Originating Department Community Development	By GPD	Approved for Agenda by:	Date: Time:	Number:
Agenda Section DEVELOPMENT BUSINESS		Item Variance and Revised Final Site Plan and Building Plans

Case 3335AB-00

**Variance for front setback for building addition
And Revised FSP & BP for additions to existing building**

Variance to reduce the required front yard setback &
Revised FSP & BP for additions to an industrial building

ZONING & CODE REVIEW:

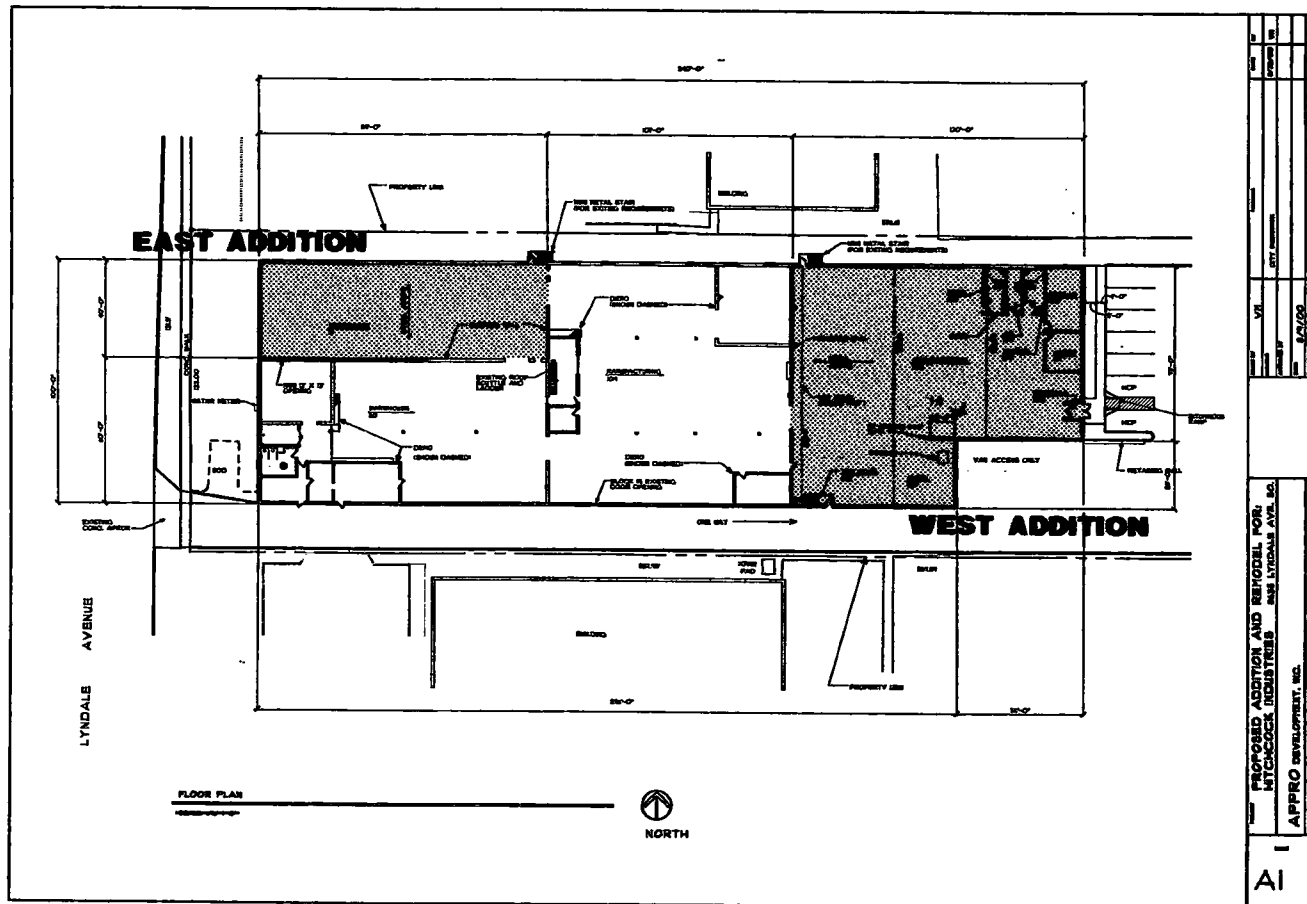
Section 19.42(c)(1) of the City Code requires that all setbacks shall be based on the planned widened right-of-way, which is 50 feet from centerline on Lyndale Avenue in this instance. The existing property line is 40 feet from centerline and the existing building has a setback of 27.8 feet from that property line. The west wall of the proposed northwest addition would match would be an extension of that existing west wall plane and have a 27.8 foot setback from the existing property line and a 17.8 foot setback from the planned widened right-of-way for Lyndale Avenue.

The applications were not reviewed by the Fire and Life Safety Committee. Public works comments include the following:

- Plat the property;
- Dedicate ROW to 50 feet along Lyndale Avenue and provide standard drainage, utility, and sidewalk easements along appropriate property lines;

- Clear one-way signage required along south driveway;
- No connection charges due;
- Provide proper radii on driveway entrance curbs, particularly on Lyndale;

- Street restoration compliance required;
- Use Bloomington Standard Details;
- Spec material 6" and 8" lines
- Complete SAC questionnaire;
- Put water meters where service enters building;

- Review cover, valving, utility line separation, and all existing property services with staff for detail needs;
- Place inspection manhole on west service;

- Review erosion control plan deficiencies with staff;
- Nine Mile Creek Watershed District permit required;
- Review storm calculations with staff for runoff control, storm cepter sizing, and other details; and

- Potential drainage problem on north side of building and can't drain roof to surface in that area.

In Case 3335B-00, staff recommends approval of revised final site plans and building plans for additions to an existing industrial building and site improvements at 8635 Lyndale Avenue subject to the following conditions being satisfied prior to the issuance of any grading or building permits:

- 1) Exterior building materials shall match those shown on plans approved in Case 3335B-00;
- 2) Building plans shall identify trash and recyclable material collection and storage area provided within the building as approved by the Fire Marshal and the Planning Manager;
- 3) Grading, drainage, utility and erosion control plans be approved by the City Engineer;
- 4) A SAC questionnaire be completed and submitted to the Department of Public Works;
- 5) Access, circulation and parking plans be approved by the City Traffic Engineer;
- 6) Erosion control measures be in place prior to issuance of grading permits;
- 7) Nine Mile Creek Watershed District permit be obtained

- 1) Three-foot high solid screening be provided along Harriet Avenue as approved by the Planning Manager (Sec. 19.52);
- 2) Landscape plan be approved by the Planning Manager (Sec 19.52);

- 3) All rooftop equipment be fully screened (Sec. 19.52.01);
- 4) Poured-in-place concrete curbs be provided on the perimeter of parking lots and traffic islands (Sec 19.64);
